New 84-TOOTH RATCHET Provides Better Access and Greater Strength

84 TOOTH RATCHET

NEW 84 TOOTH RATCHET PART NUMBERS

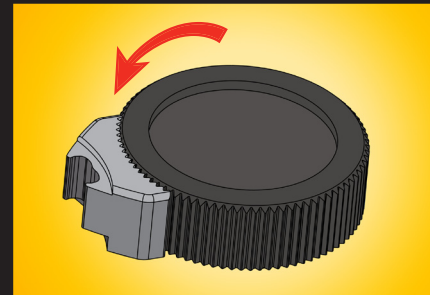
Taking the place of our top-of-the-line 60-tooth ratchet is the new and improved GearWrench 84-tooth ratchet, which provides even better access and greater strength. It features a fine tooth gear which reduces the return swing arc from 6 degrees to just 4.3 degrees for better access and also tests to 200% (+/-10%) of the ANSI specification for strength.

FINE TOOTH GEAR: 4.3° RATCHET ARC

Flush-mounted lever for On/Off Switch

Fine Tooth Gear: 4.3° Ratchet Arc

Low-Profile Head provides access in tight confines, up to 21% more access than the competition

EXISTING 60 TOOTH RATCHET PART NO.	REPLACED BY NEW 84 TOOTH RATCHET PART NO.	PRODUCT NAME
81011	81011F	1/4" Drive Full Polish Teardrop Ratchet
81012	81012F	1/4" Drive Full Polish Flex Teardrop Ratchet
81007	81007F	1/4" Drive Cushion Grip Teardrop Ratchet
81009	81009F	1/4" Drive Cushion Grip Flex Teardrop Ratchet
81211	81211F	3/8" Drive Full Polish Teardrop Ratchet
81215	81215F	3/8" Drive Full Polish Flex Teardrop Ratchet
81209	81209F	3/8" Drive Full Polish Stubby Teardrop Ratchet
81212	81212F	3/8" Drive Full Polish Stubby Flex Teardrop Ratchet
81214	81214F	3/8" Drive Full Polish Offset Flex Teardrop Ratchet
81208	81208F	3/8" Drive Cushion Grip Teardrop Ratchet
81210	81210F	3/8" Drive Cushion Grip Flex Teardrop Ratchet
81213	81213F	3/8" Drive Cushion Grip Offset Flex Teardrop Ratchet
81304	81304F	1/2" Drive Full Polish Teardrop Ratchet
81306	81306F	1/2" Drive Full Polish Flex Teardrop Ratchet
81303	81303F	1/2" Drive Cushion Grip Teardrop Ratchet

* All socket sets currently containing the 60 tooth ratchet will be upgraded to the new 84 tooth ratchet as a running change. Upgraded sets will be easily identifiable by the label pictured right. Socket set part numbers will not change.
